NUREG-0097

## **MARBLE HILL NUCLEAR GENERATING STATION UNITS 1 and 2**

Docket Nos. STN 50-546, STN 50-547

FINAL ENVIRONMENTAL STATEMENT

Fig. 2.7. Period of Record Wind Rose, January-December 1974, 33-Foot Level, Onsite Tower #1. From PSAR, Figure 2.3-4.

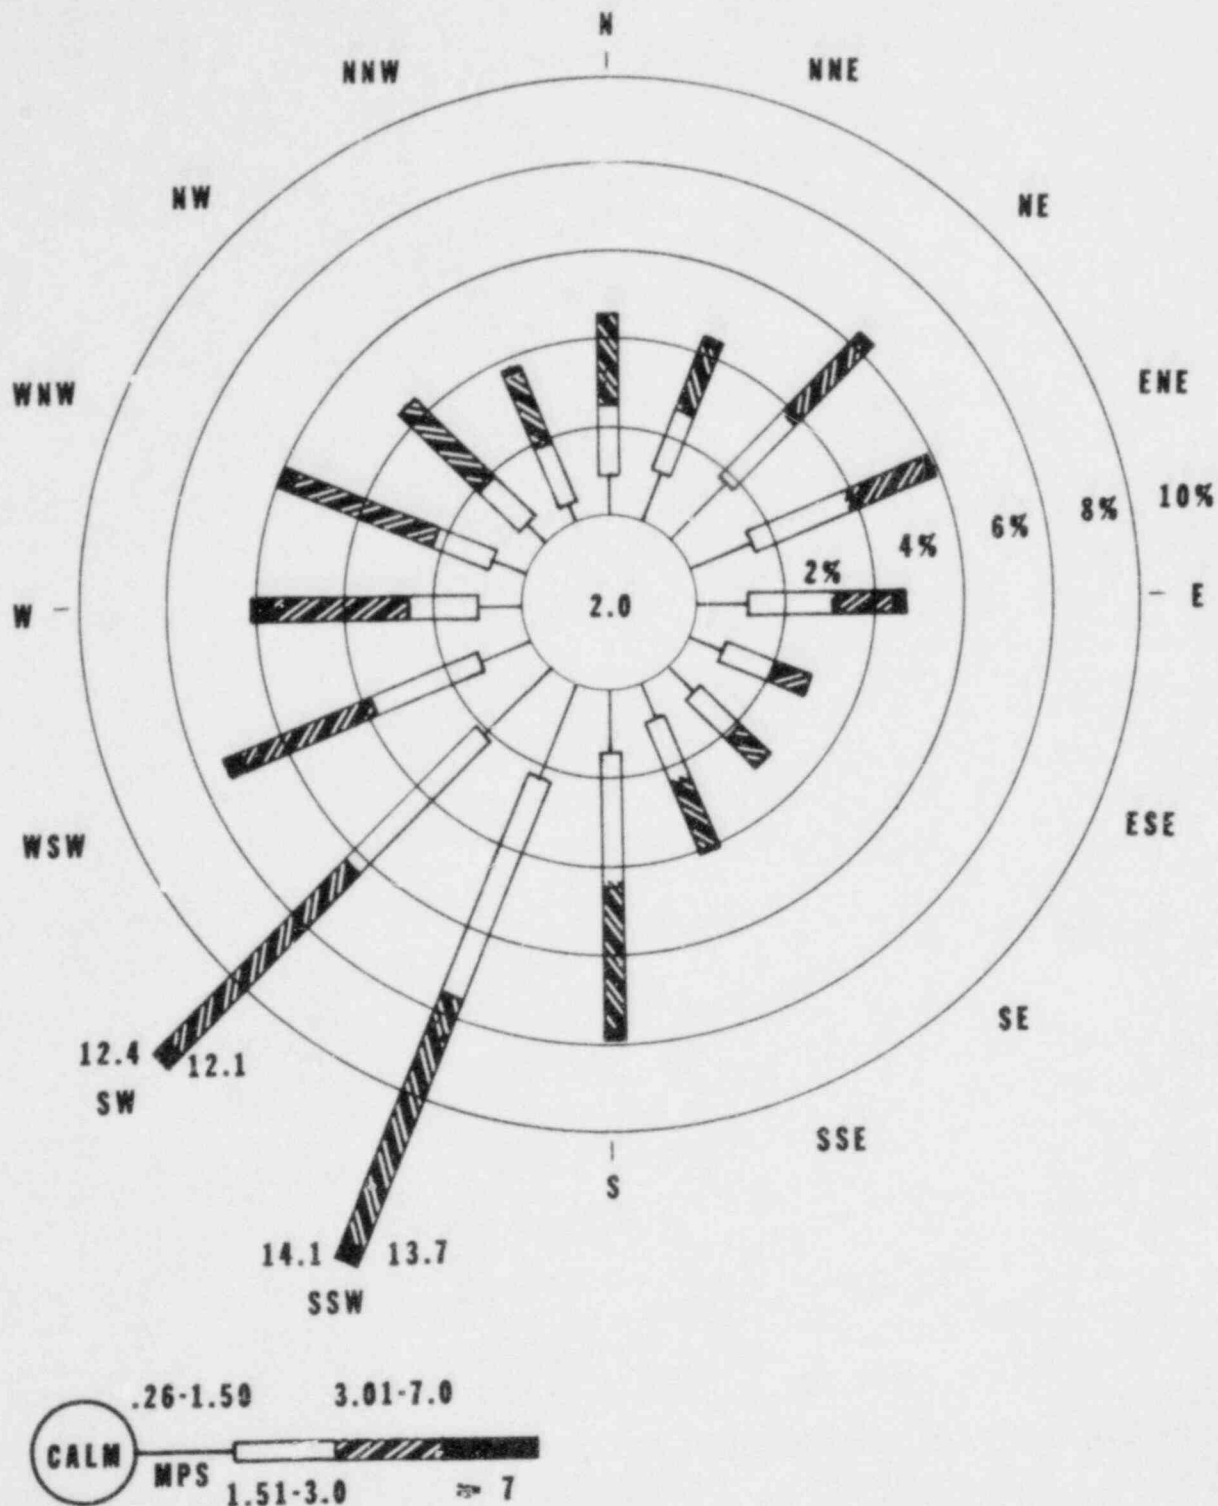
We should like to point out one minor inconsistency. The text on page 2-13, paragraph 8, in referring to Figure 2.7, indicates a 33-foot level wind rose. However, on page 2-17, the Figure 2.7 caption indicates the wind rose is for the 200-foot level.

- 8) 2.6.2. From the map, Figure 2.4, it seems clear that Madison is NE of the site, not NNE as given in the first paragraph. Further, the wind roses, e.g. Figure 2.7, indicate that for a significant part of the time Madison, and also Louisville, will be down-wind of the plant. No adequate evaluation of this relative to radioactive effluents is given.

Fig. 2.8. Summary Wind Rose, January-December 1974, 33-Foot Level, Satellite Tower along River. From PSAR, Figure 2.3-18.

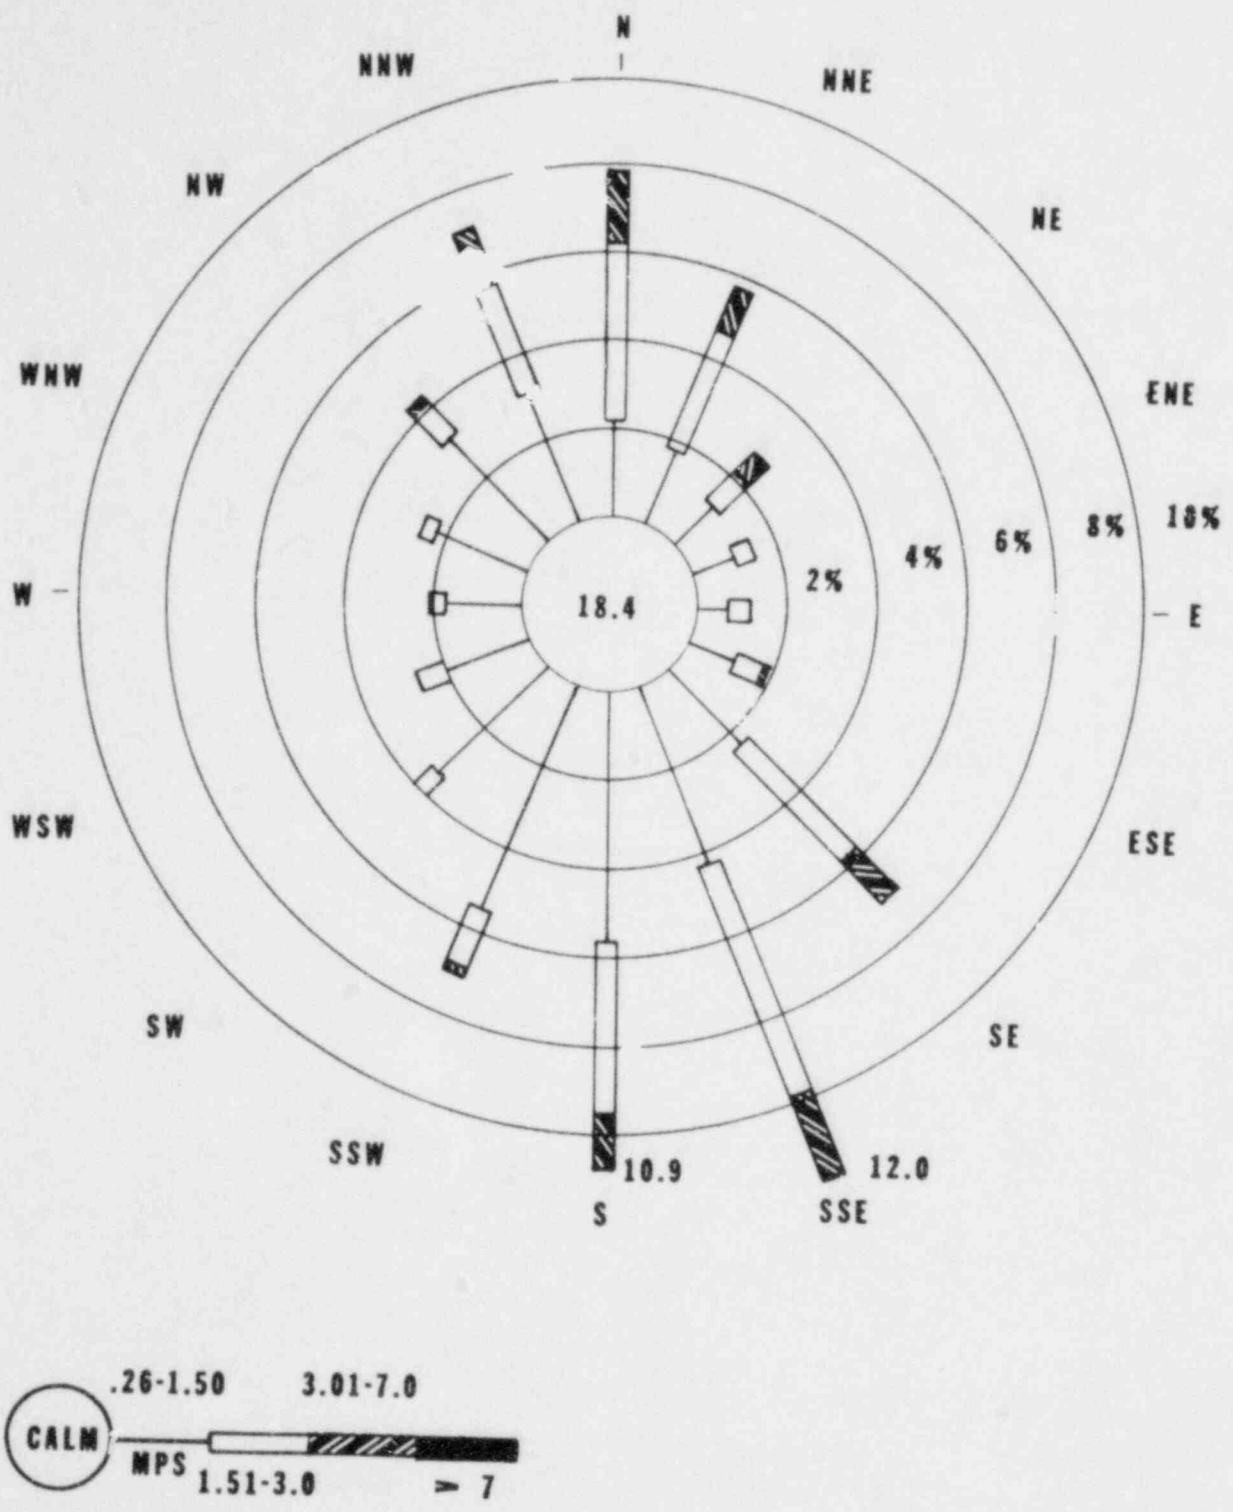
A more complete discussion of the hardwood forest could be included. The differences between upland and hillside forests are unclear. Figure 2.8 could be revised to reflect these differences.

Fig. 3.3. Water Use Flow Diagram. From ER, Fig. 3.3-1.

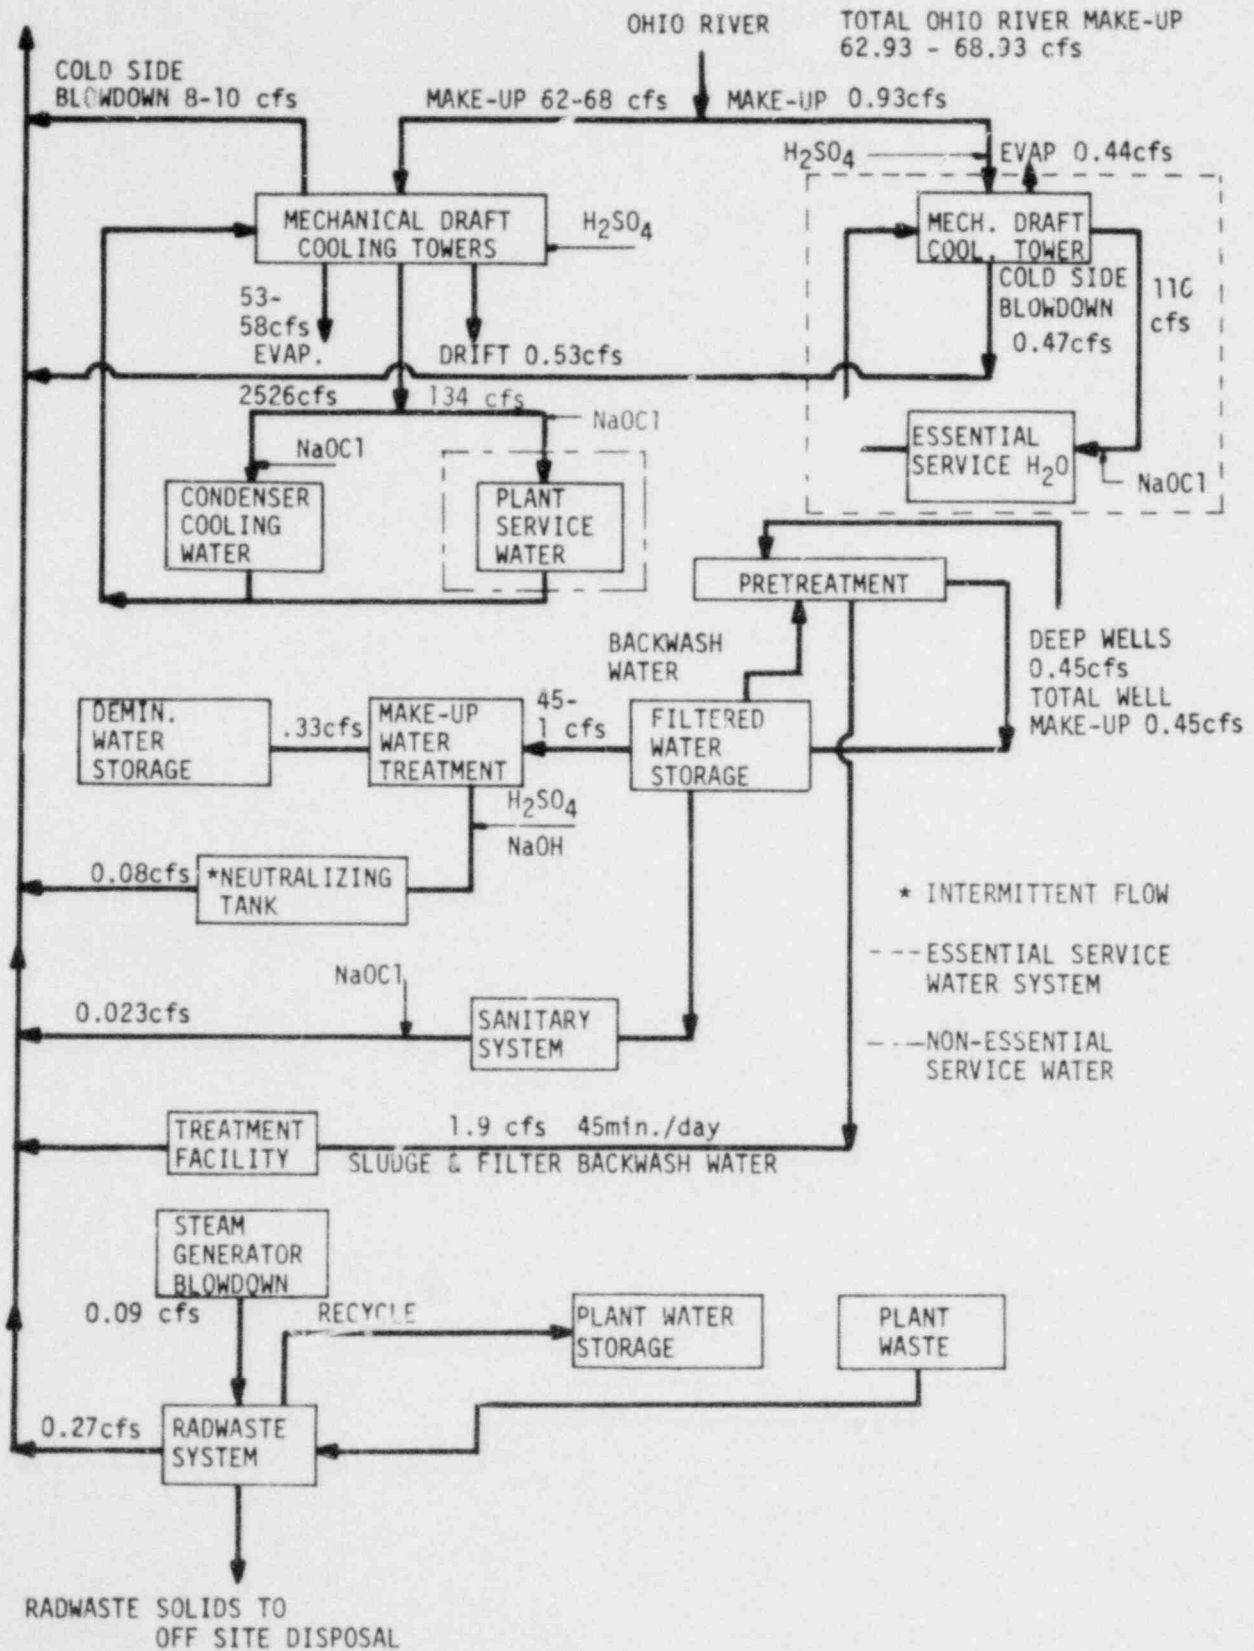
5. Ref. Fig. 3.3: At the bottom of this flow chart there is an arrow indicating flow of Radwaste Solids to off site disposal. At this time no such off site disposal facilities exist, and due to problems such sites may be a long way into the future. In view of this situation we feel that the section on environmental considerations of the uranium fuel cycle should be done on a more realistic basis and in much more detail, and specifically, we want precise clarification of how, where, and when radwaste solids will be disposed. The cost of the disposal and storage facility, that part attributed to the Marble Hill Station, should be factored into the economic justification of the proposed station.

Fig. 3.6. Intake Flume and River Screen House. From ER, Fig. 3.4-2.

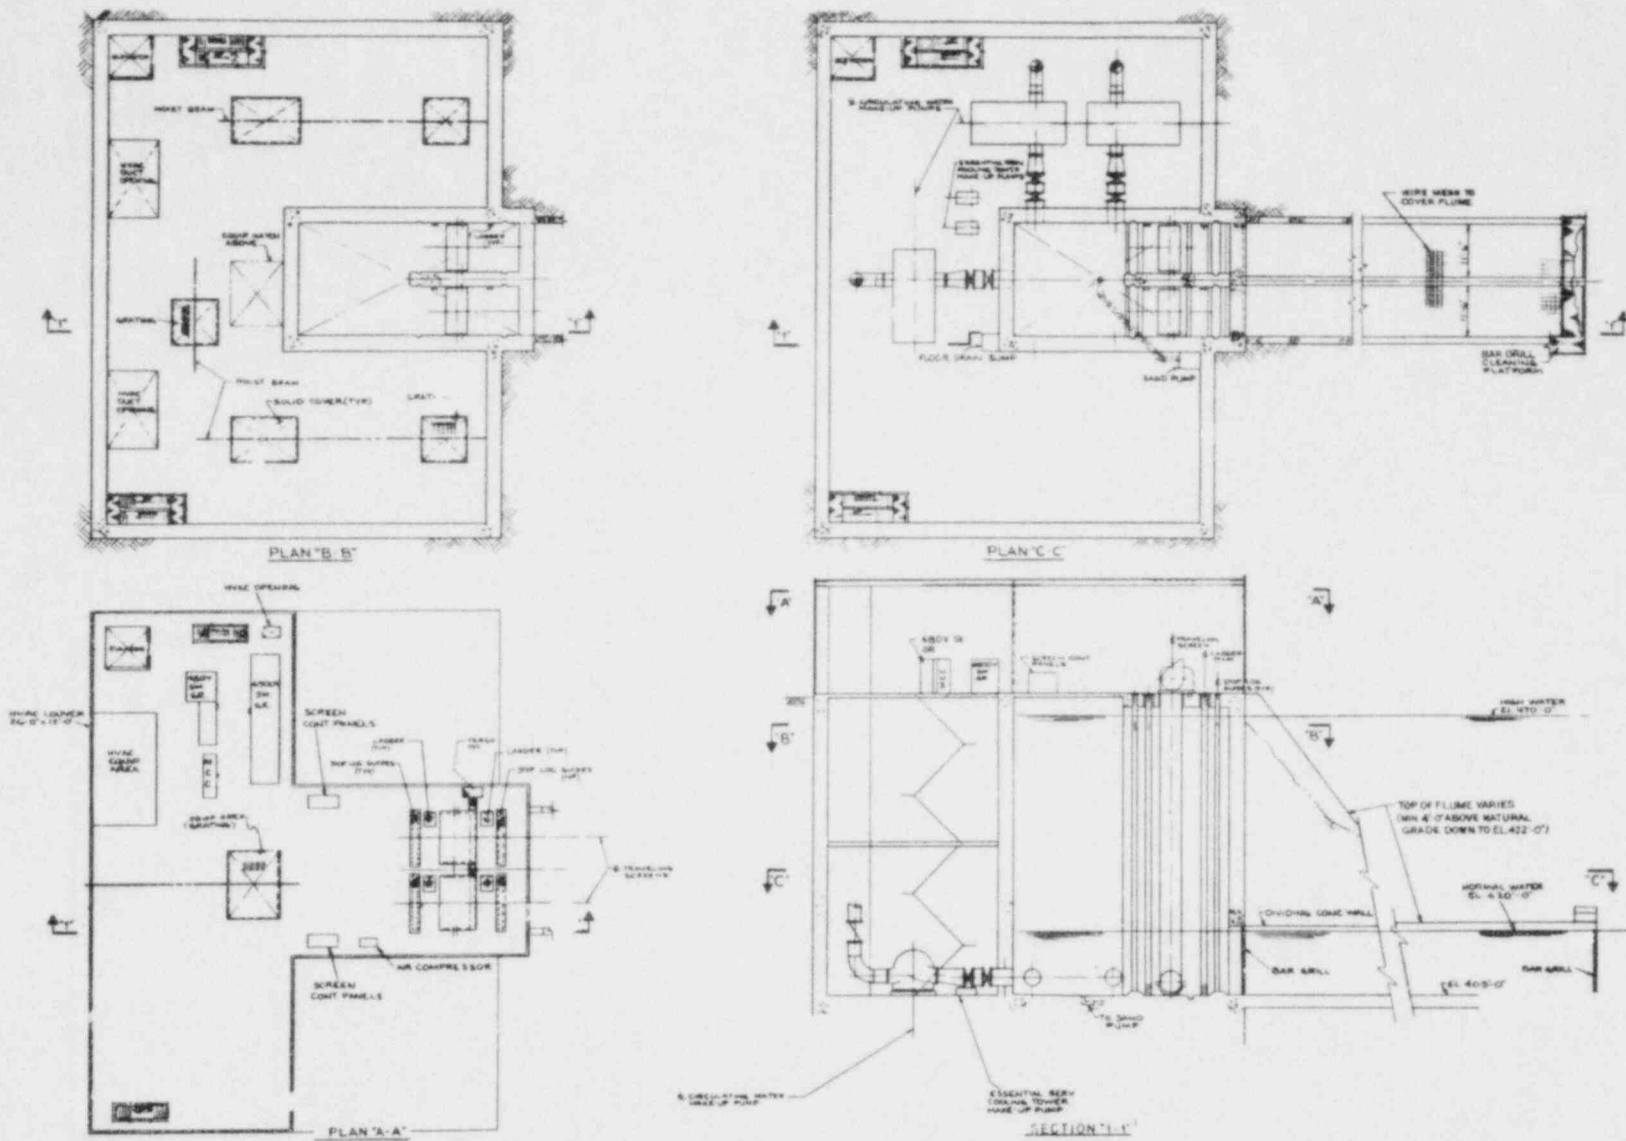
6. Ref. 3.4.2: The intake structure shown in Fig. 3.6 delineates the three makeup water pumps in the same enclosure. This does not provide any redundancy in the event of a structural failure that would flood the pump room. At least one degree of redundancy should be provided for a function as critical as the makeup water supply.

Fig. 3.13. 345-kV Double-Circuit Self-Supporting Tower. From ER, Fig. 3.2-4.

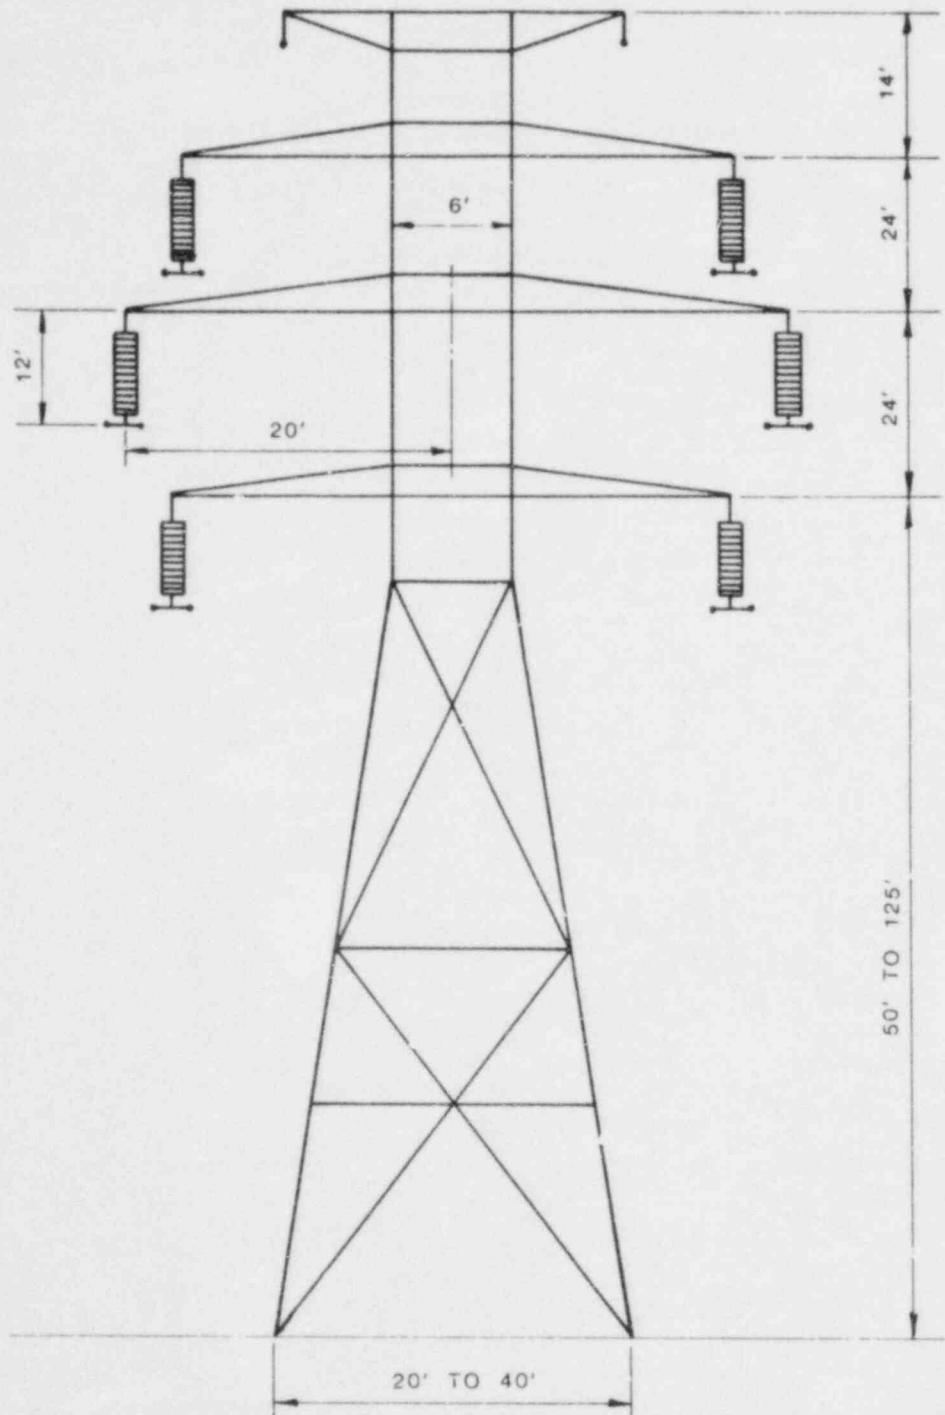
4-4	4.3.1.1	In the second paragraph of this section, the staff's statement that transmission wires will be a minimum of 40' apart is incorrect. As shown in the DES, Figure 3.13, the vertical spacing on 345 kV double circuit towers is approximately 24'.	4-5	4.3.1.2	With respect to the listing of requirements on herbicide application, PSI requests that these be deleted on the grounds that herbicide usage standards are developed by the EPA and users of herbicides are licensed by the State of Indiana based on EPA standards.
4-4	4.3.1.1	The wording of the 7th and 8th paragraphs concerning the Indiana bat and bobcat assumes that, in fact, these animals presently inhabit the site. The surveys done for the Indiana bat did not reveal any Indiana bats to be present and only indications that a bobcat may have been present were seen. Furthermore, the implication that the bobcat, if he does inhabit the site, would not be able to find suitable habitat elsewhere does not appear to have any basis. In addition, the discussion of the Indiana bat conflicts with the requirement in the Summary and Conclusions Section to do an additional survey to determine its presence on the site.			With respect to item (1), definition of a "conservation area" is requested. PSI has working agreements with the Indiana Department of Natural Resources and the U.S. Forest Service on the use of herbicides in such areas. These organizations in many instances prefer a herbicide treatment in the right-of-way. Furthermore, each county in Indiana is considered a "Soil and Water Conservation District" and under strict interpretation of the requirement as stated by the staff, herbicides would not be able to be used within Indiana.
